Addendum No. 2

Date: May 3, 2019

Project: Kelso School District
Kelso High School CTE Remodel
Project Number 2019-01
Longview, WA

1
P3.1

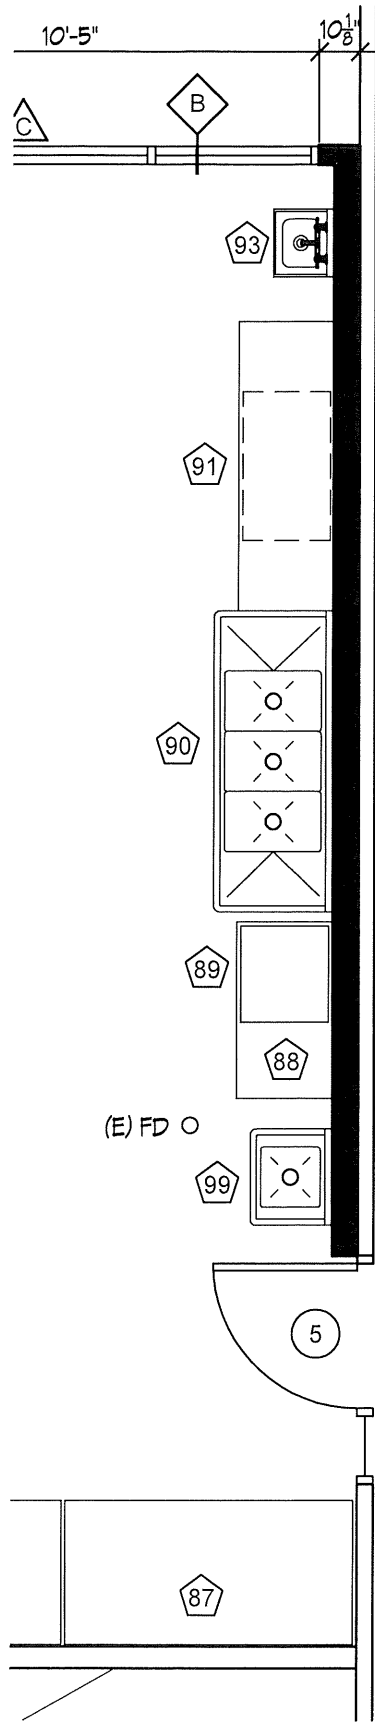
| 2.8 | P3.1 | <ul style="list-style-type: none"> A. REVISE Floor plans per attached drawing. |

A3.1

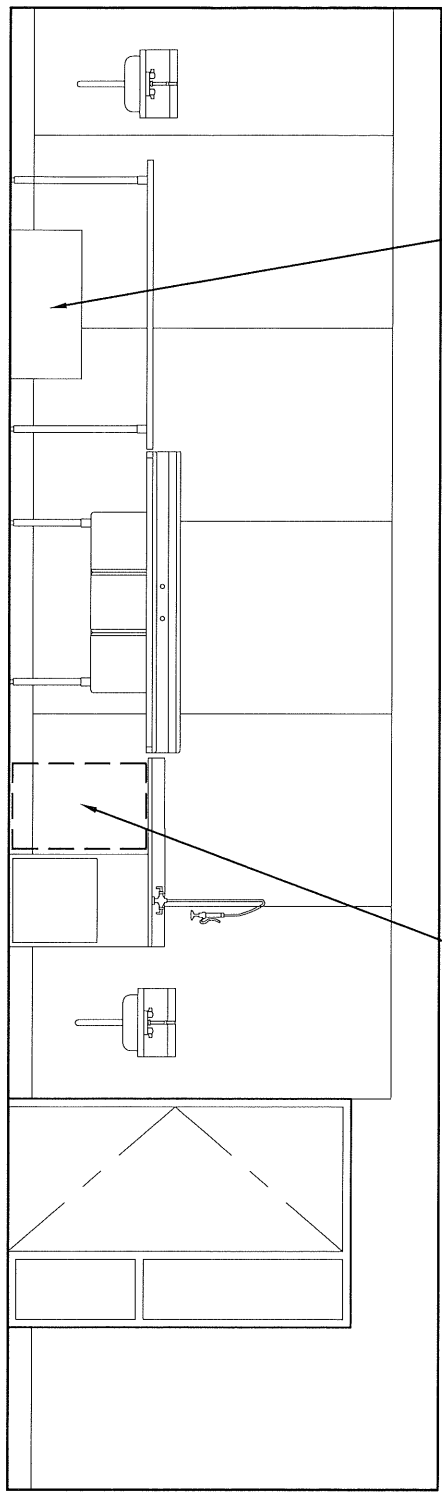
2.3	A3.1	Revise the equipment layout on the east wall of room 377 per the attached. Triple sink equipment item 91 will be deleted and replaced with an owner provided stainless steel table 72" x 30". The grease interceptor will be located below the new table and not in the southeast corner of Lecture/Dining Area 373.
